December 17, 2022

Re: Joyce Lake DS0 Iron Ore Project: Changes - December 13, 2022, Feasibility Study

This letter is to inform IAAC of key changes (the Changes) between the Draft EIS and the 2022 Study. JDI believes the Changes are not material and do not require significant additional consultation, adjustment to IAAC's Draft EIS technical review or collection of additional baseline data.

1. Site, Haul Road and Astray Loadout General Arrangement – 2022 Study

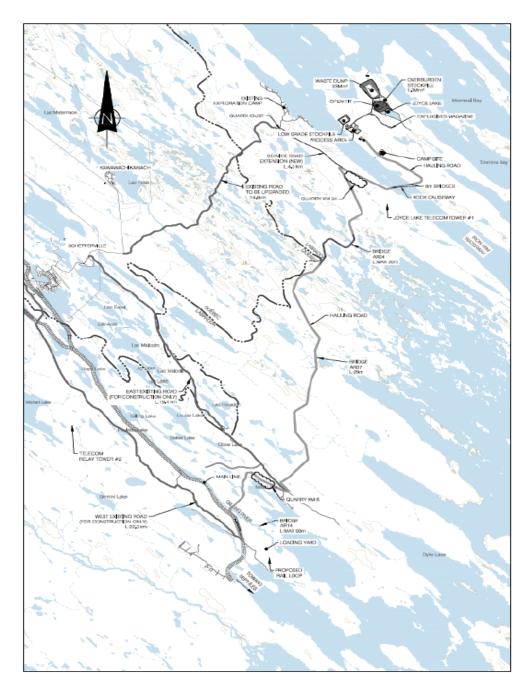
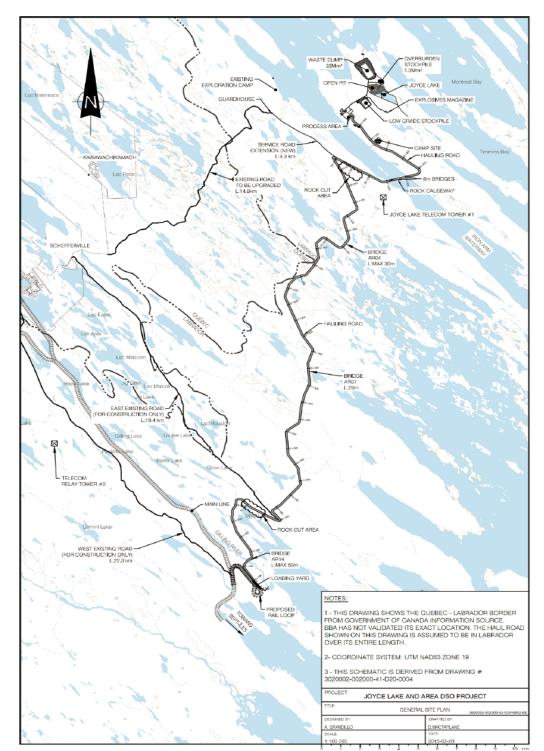
- Annually, transported tonnage is reduced by 17,500 tonnes of water
- Haul truck/train frequency is reduced by a third (reducing emissions intensity)
- Product storage capacity for rail and port transfers are reduced
- Haul truck/rail loadout workers are full time, rather than seasonal
- The Project is more economically robust
- A 875,00 DMT (peak) dried lump stockpile is located at the mine site crushing pad
- Diesel fuel consumption increases by 1.1ML/a or 5.39% annually.
- b. The dedicated product haul road between the mine site and Astray rail loadout uses the same route, but road width is reduced to a single lane with passing pull-outs at 1Km intervals. Continuous truck haulage requires only 12-95 t haul trucks.
- c. At the planned Astray rail loadout improved design now requires installation of 2.4Km of new track compared to 6.9Km previously.

2. Mine Site General Arrangement – 2022 Study

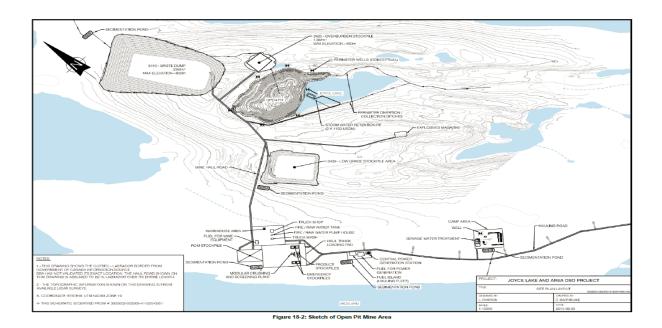
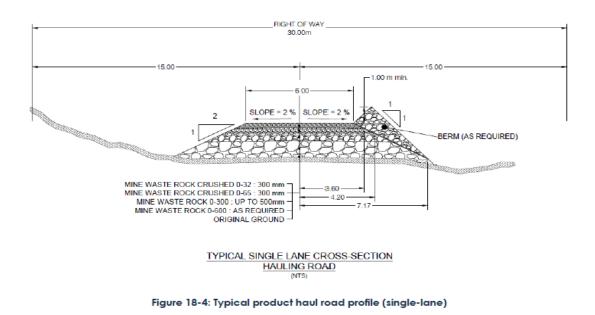
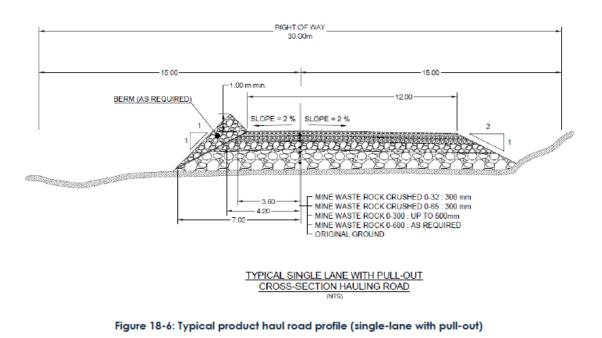
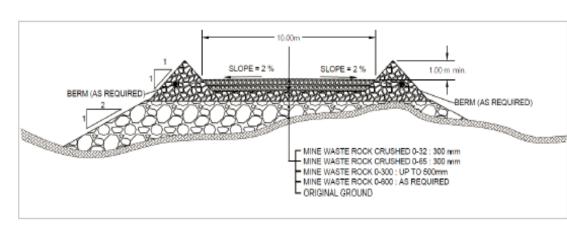
Additionally, the lower grade ROM stockpile, which will be reclaimed, and crushed and transported to market at the end of mine life, has been relocated from between the open pit and crushing pad, to the crushing pad at the mine site. The relocation reduces energy required during reclaim.
